Subject: Lower Plum Creek WS SCS Site 38 Dam – TX04369
Caldwell County
Dam Safety Inspection Report

DAM SAFETY INSPECTION REPORT

DAM: Lower Plum Creek WS Site 38 Dam

Photograph 4: Upstream looking left. Note vegetation among riprap.

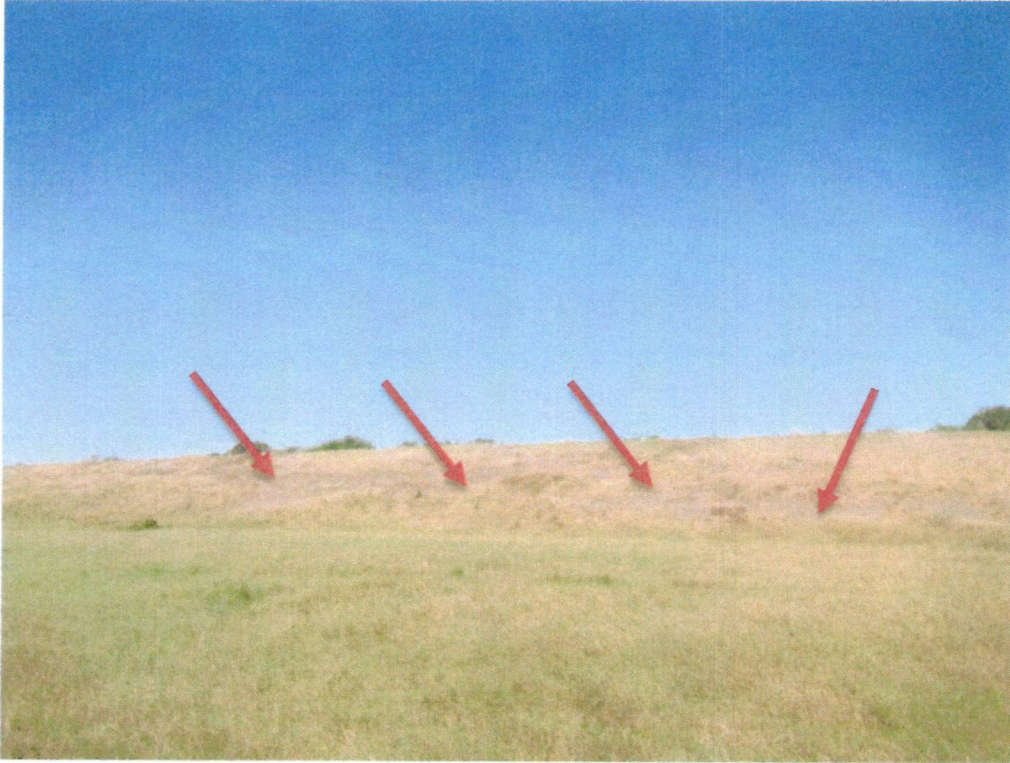
- The 2.5 horizontal to 1 vertical [2.5H:1V] upstream slope of the earthen embankment was covered with grass, and the grass was of sufficient density.
- The upstream riprap was performing well, and no excessive erosion was noted, however, there was significant vegetation growing within the riprap.
- The upstream slope was found to be in good condition.
- See photographs 3 and 4.

- e. Appendix C of the *Guidelines for Operations and Maintenance of Dams in Texas* discusses possible pre-emergent herbicides (acceptable for use near reservoirs) for use on the vegetation covered upstream slope riprap.

Photograph 9: Principal Spillway outlet pipe and plunge pool.

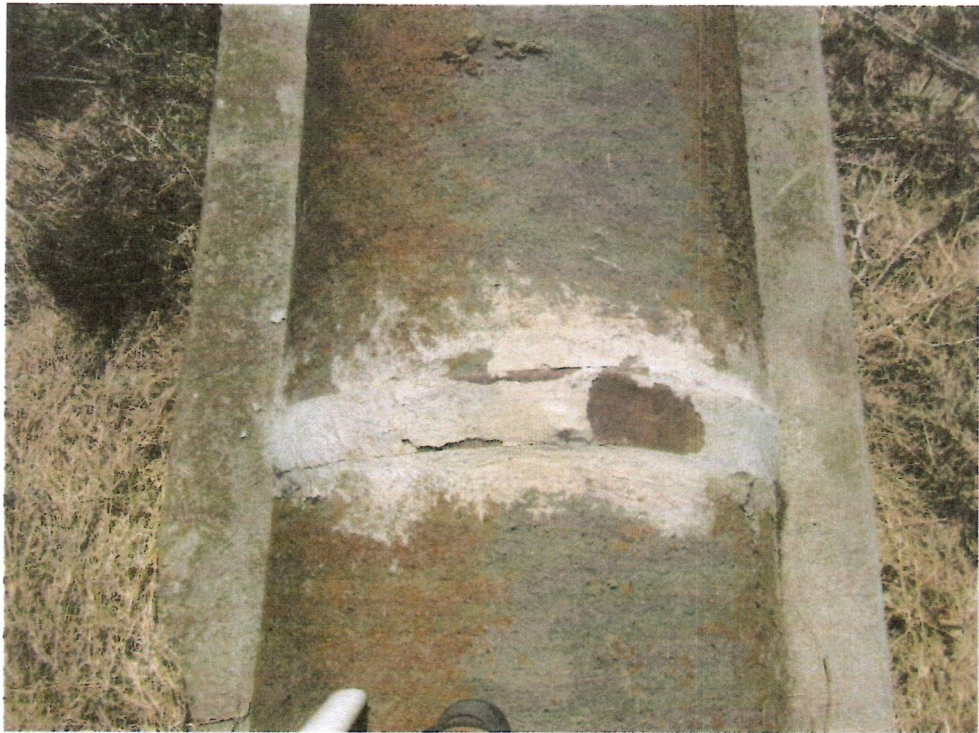
- The channel downstream of the plunge pool contained trees and brush that have the potential to restrict flow from the plunge pool.
- See photograph 9.

- a. Monitor on a regular basis the spalling and pipe joint sealant degradation at the discharge outlet pipe until repairs are made.
- b. Monitor on a regular basis the plunge pool discharge flow to ensure it is not restricted excessively. If the flow is restricted then clear a path for the discharge.
